Subject: Attachments: Ore Dock Approach Slab Handrail 2024-061 Jesse Proposal Letter 05292024.pdf; 2024-05-21_Skagway CDT Approach Slab Railing AP Markups.pdf

From: Cody Jennings Sent: Wednesday, May 29, 2024 2:55 PM To: Brad Ryan <<u>manager@skagway.org</u>> Subject: FW: Ore Dock Approach Slab Handrail

Re: Skagway Ore Peninsula Redevelopment Skagway, AK

CRUISE DOCK TRESTLE SURFACE FEATURES PLAN

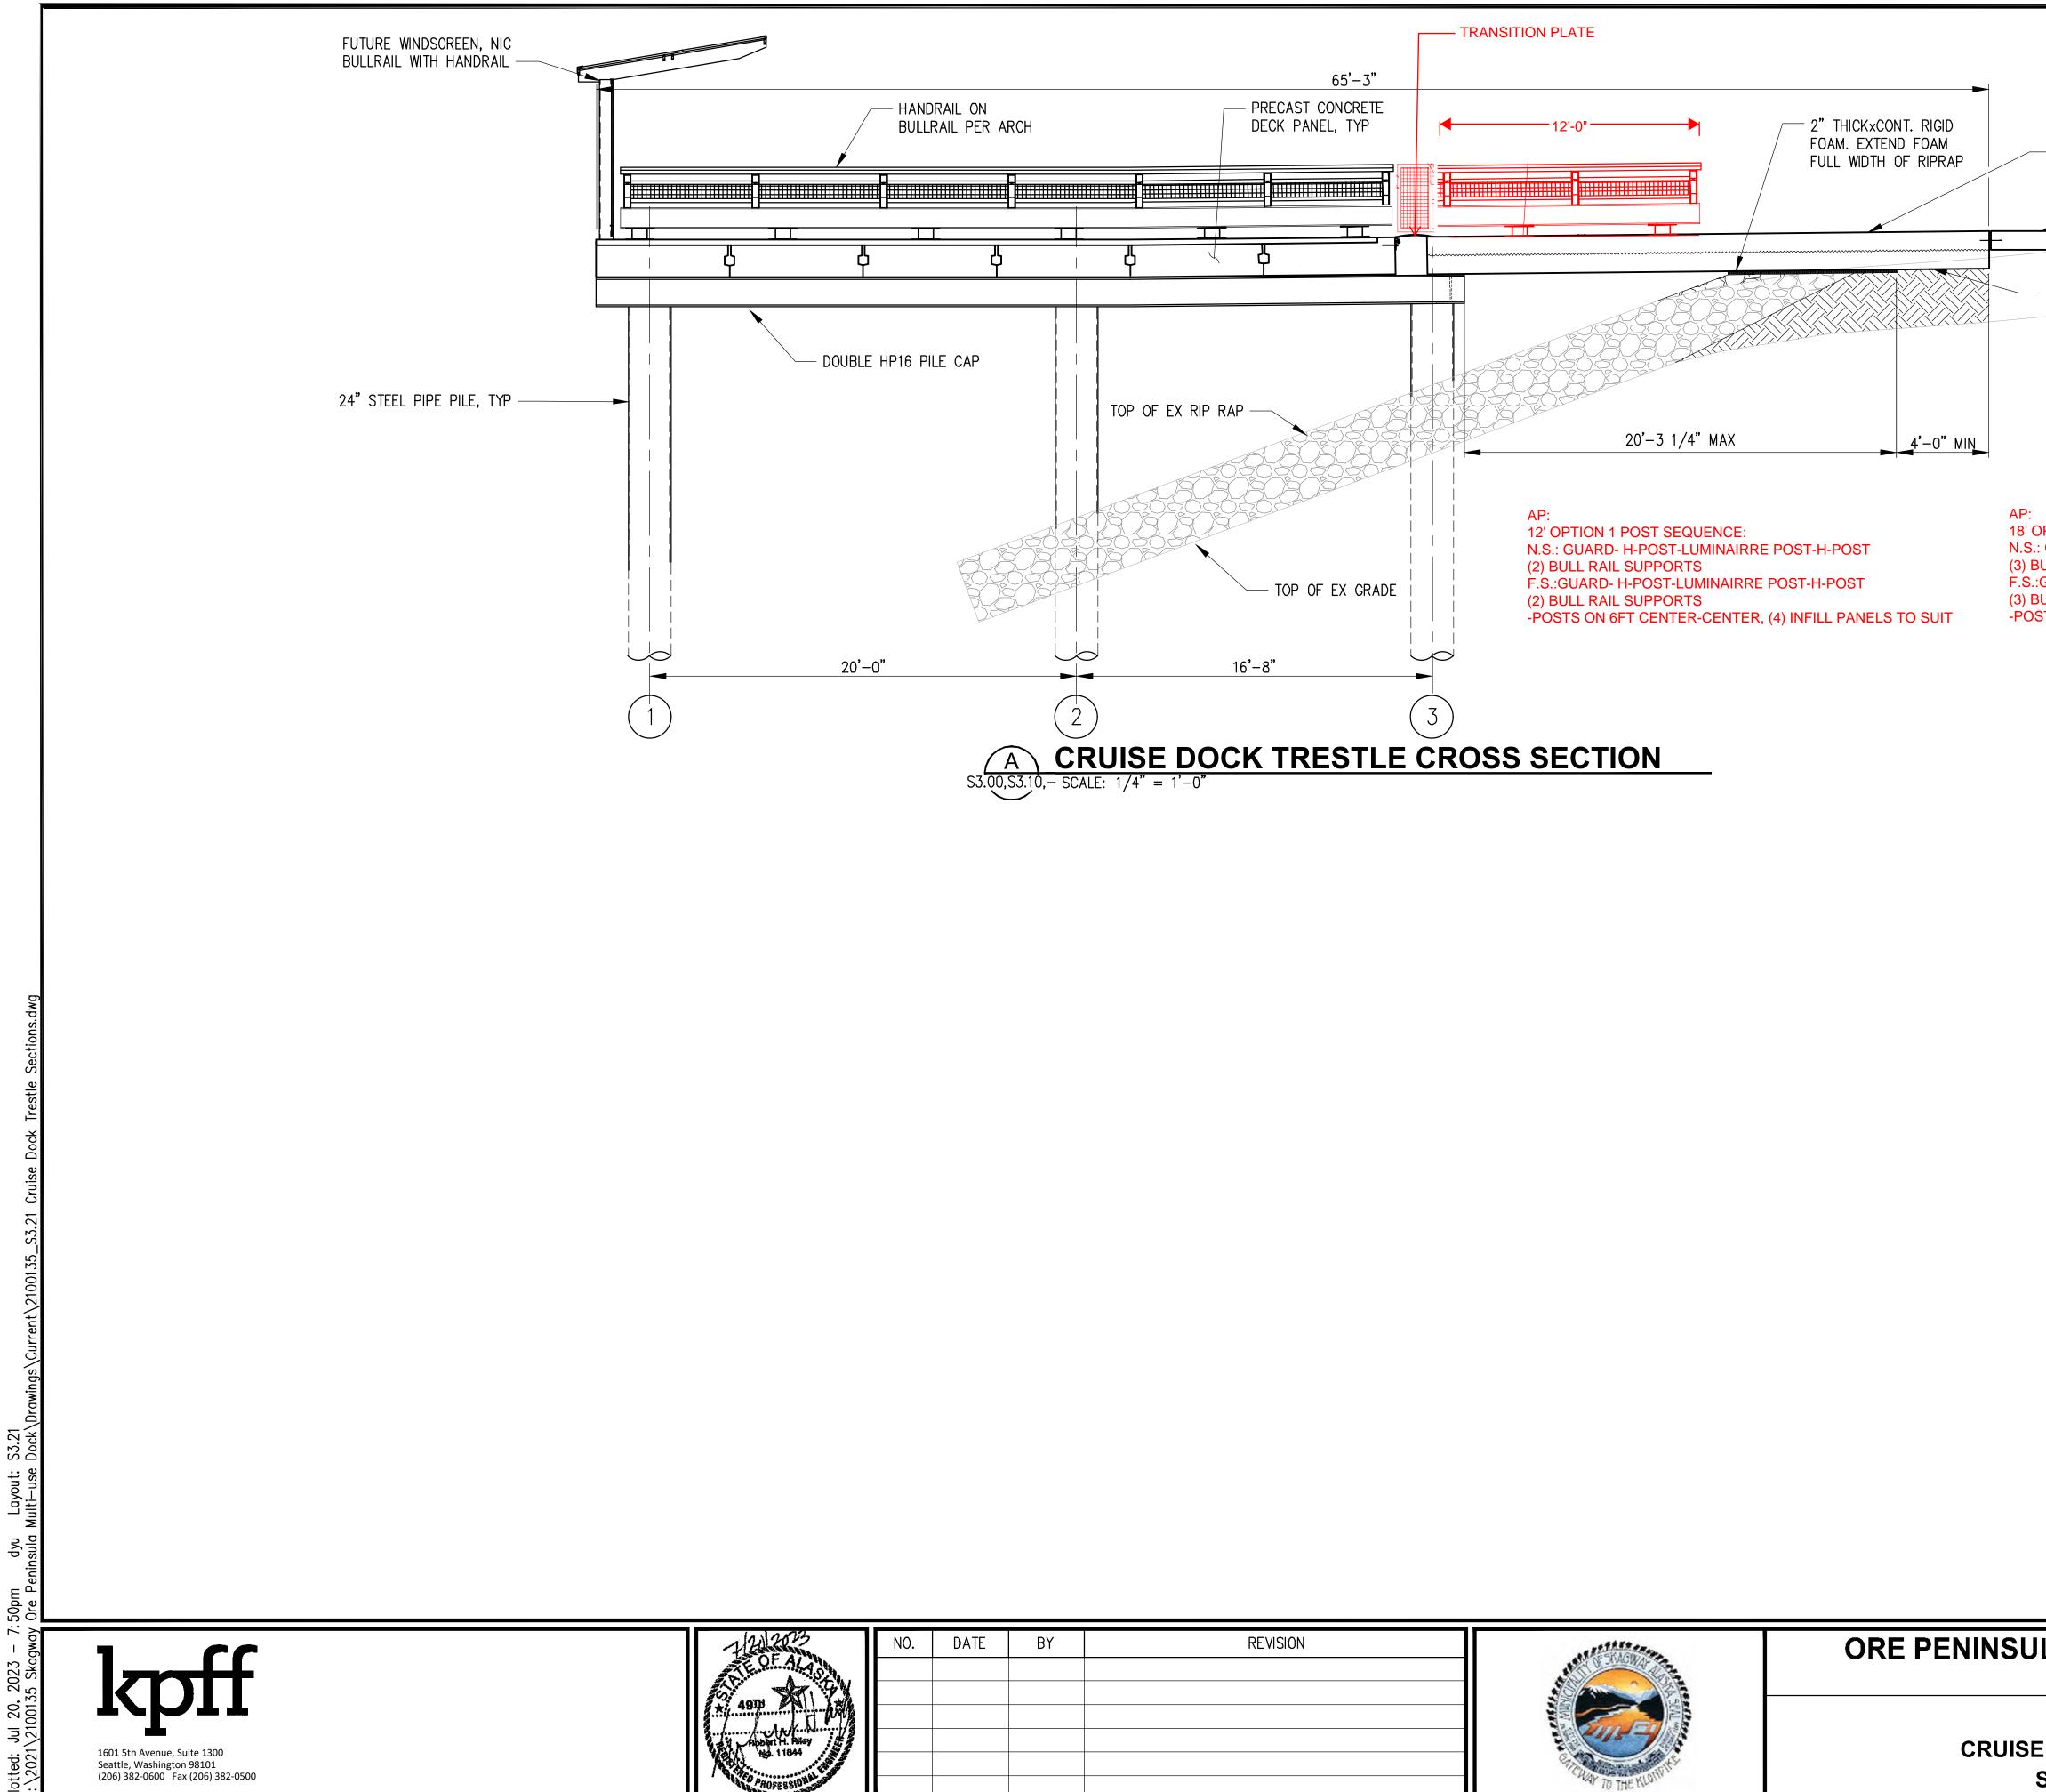
16'-8"	3 26'-1"	A 53.26	
	AP: EXISTING CD TRESTLE BULLRAIL		B S3.26 APPR	OACH SLAB
		S SLAB OVER PRECAST DR TOPPING SLAB PLAN, SEE $\begin{pmatrix} 1 \\ S3.12 \end{pmatrix}$	AP: OPTION 1- 12' LONG RAIL EXTENSION - 3 POSTS EACH SIDE, 6' CL-CL OPTION 2- 18' LONG RAIL EXTENSION (4) POSTS EACH SIDE, 6' CL-CL	
	A S3.22 TYP UTILITY SUPPORT SUPPORT	CRUISE DOCK TRESTLE DECK OUTLINE. FOR DECK PANEL PLAN, SEE 1 S3.11	— MHHW = 16.73'	
	LIFE RING AND EXTINGUISHER C B S3.22			
		- CRUISE DOCK ACCESS RAMP - PILE CAP BELOW	E FEATURES	
S2.	02 SCALE: $3/16" = 1'-0"$	EVISION

LA REDEVELOPMENT	DRAWN: MRV	PROJECT NO.:
VAY, ALASKA	DESIGN:	SCALE: AS SHOWN
,	CHECKED: $P \vee$	DATE: 7/21/2023
LK BENCHES EXPANSION	DRAWING NO.	A2.11
ND CORNERS	SHEET NO.	54 OF 381

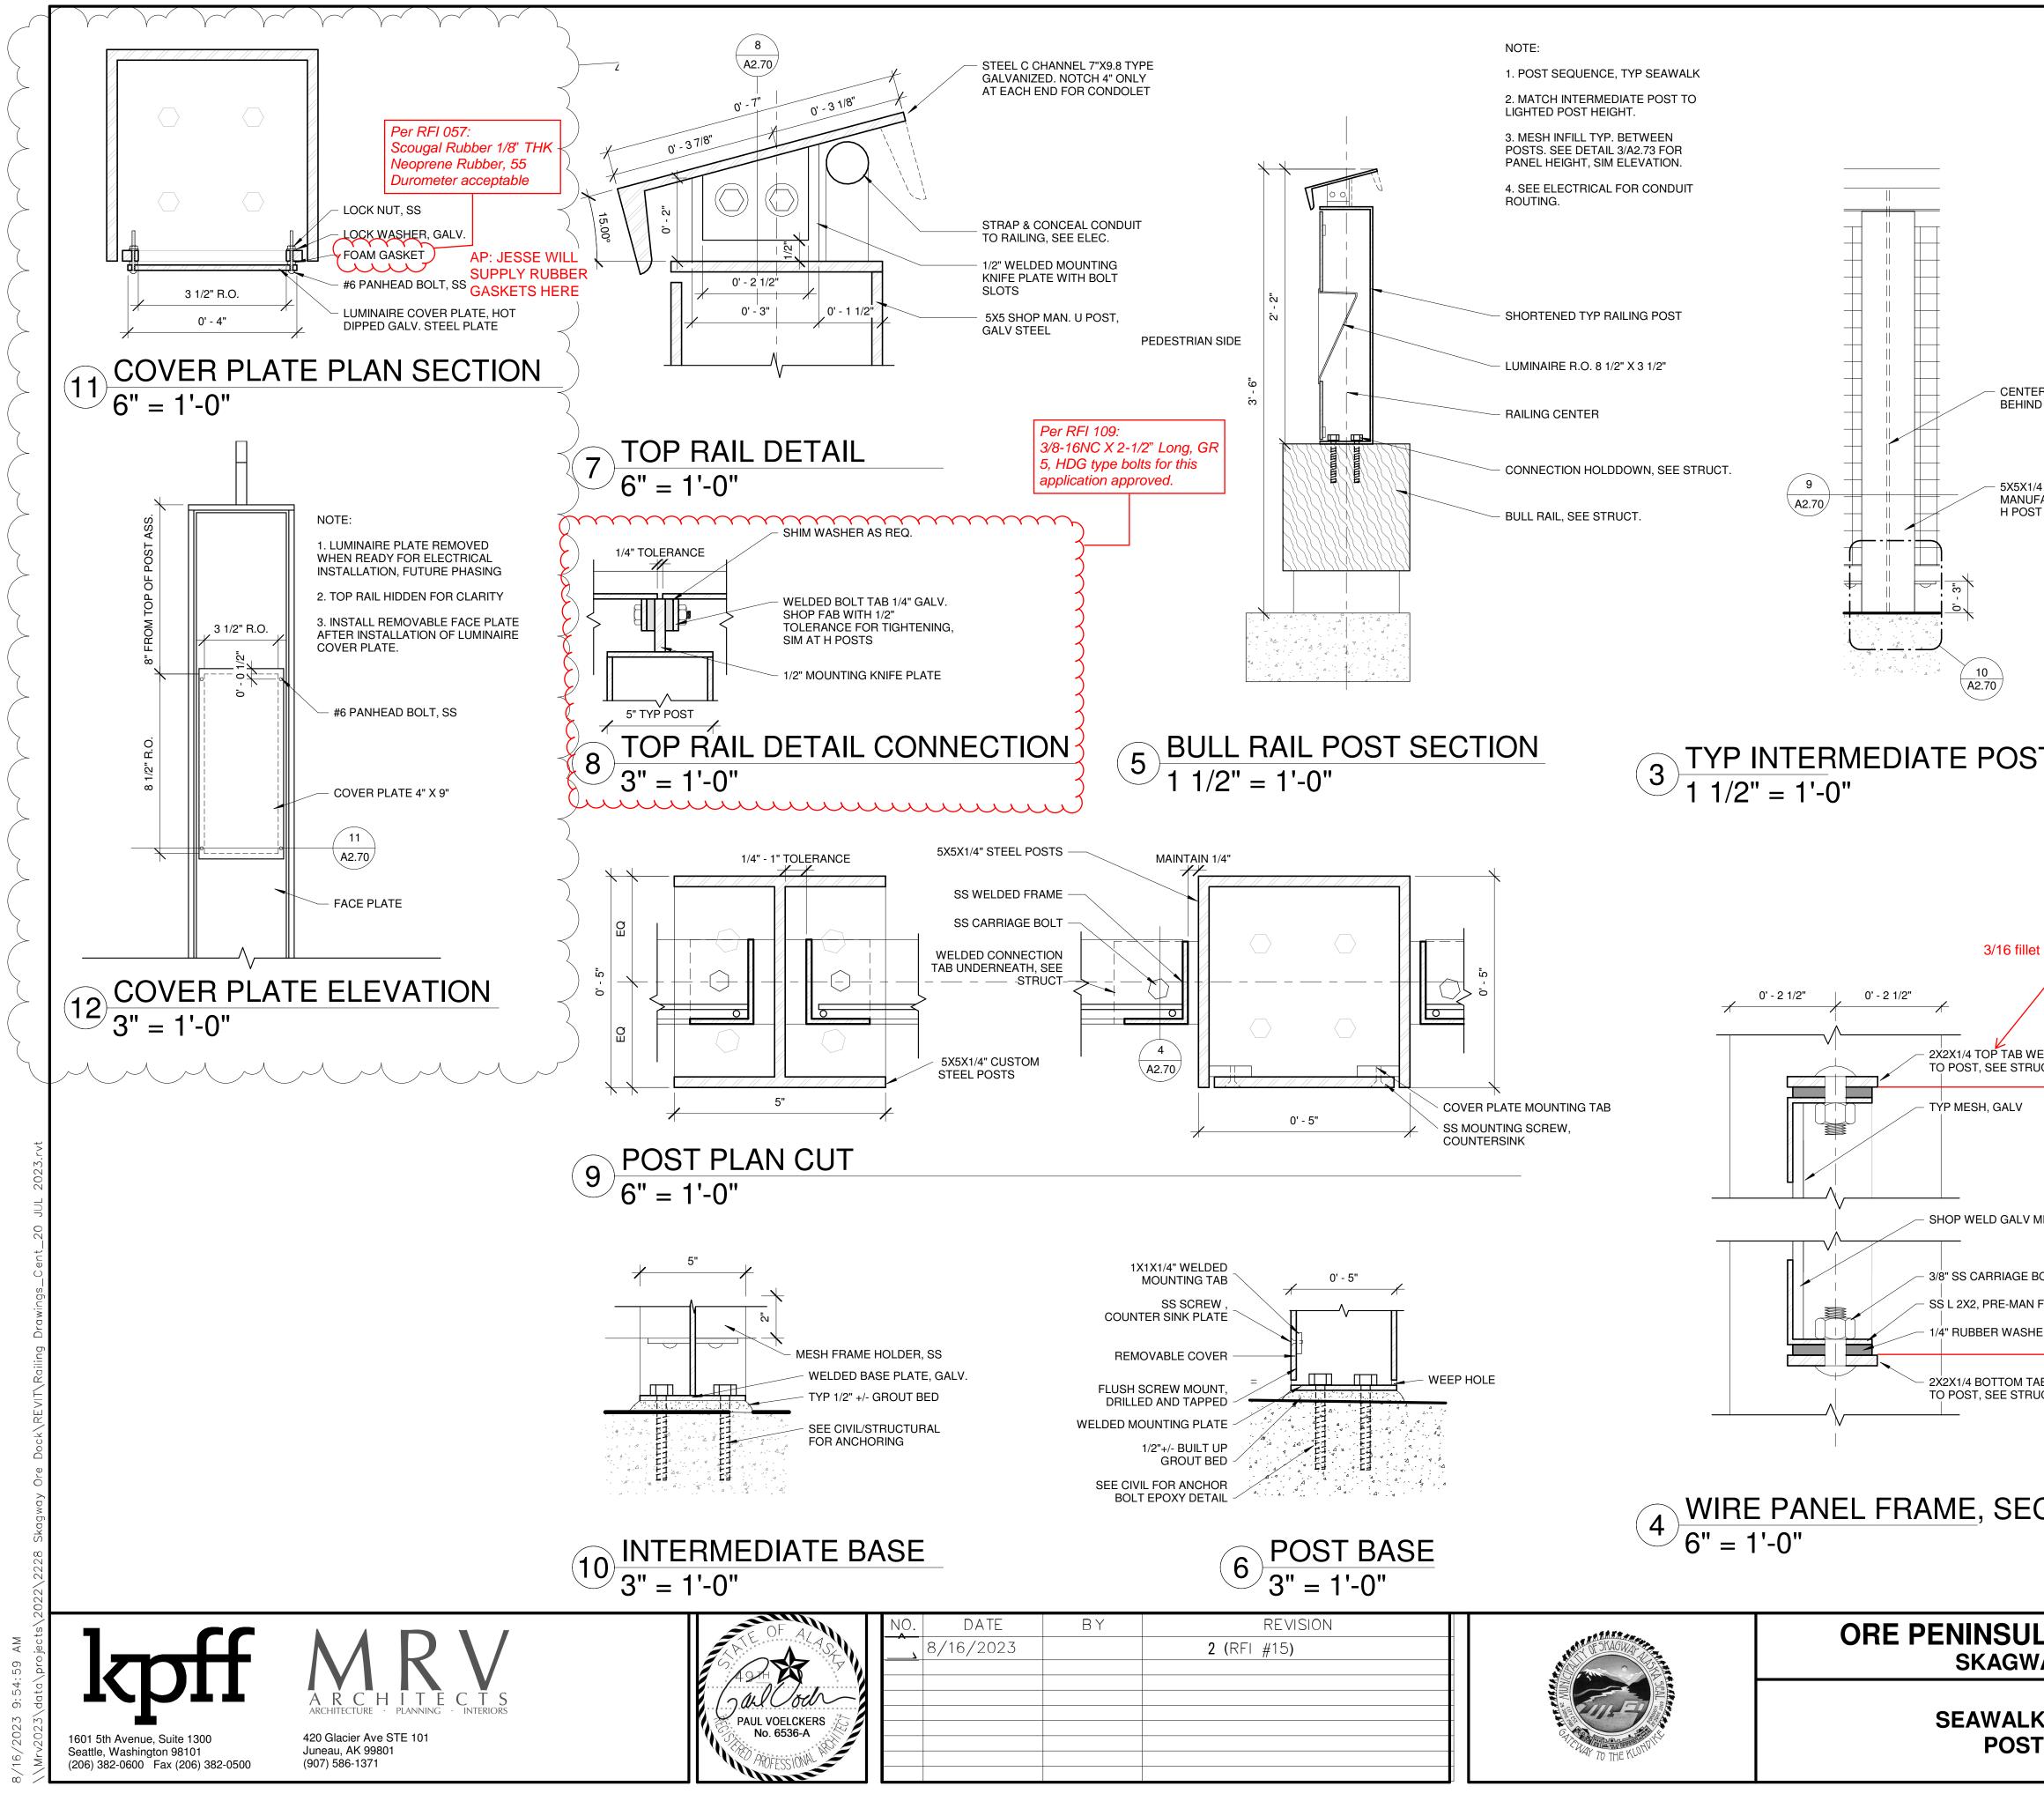
18' OPTION 2 POST SEQUENCE:

N.S.: GUARD- H-POST-LUMINAIRRE POST-H-POST-LUMINAIRRE POST (3) BULL RAIL SUPPORTS

F.S.:GUARD- H-POST-LUMINAIRRE POST-H-POST-LUMINAIRRE POST

(3) BULL RAIL SUPPORTS -POSTS ON 6FT CENTER-CENTER, (6) INFILL PANELS TO SUIT
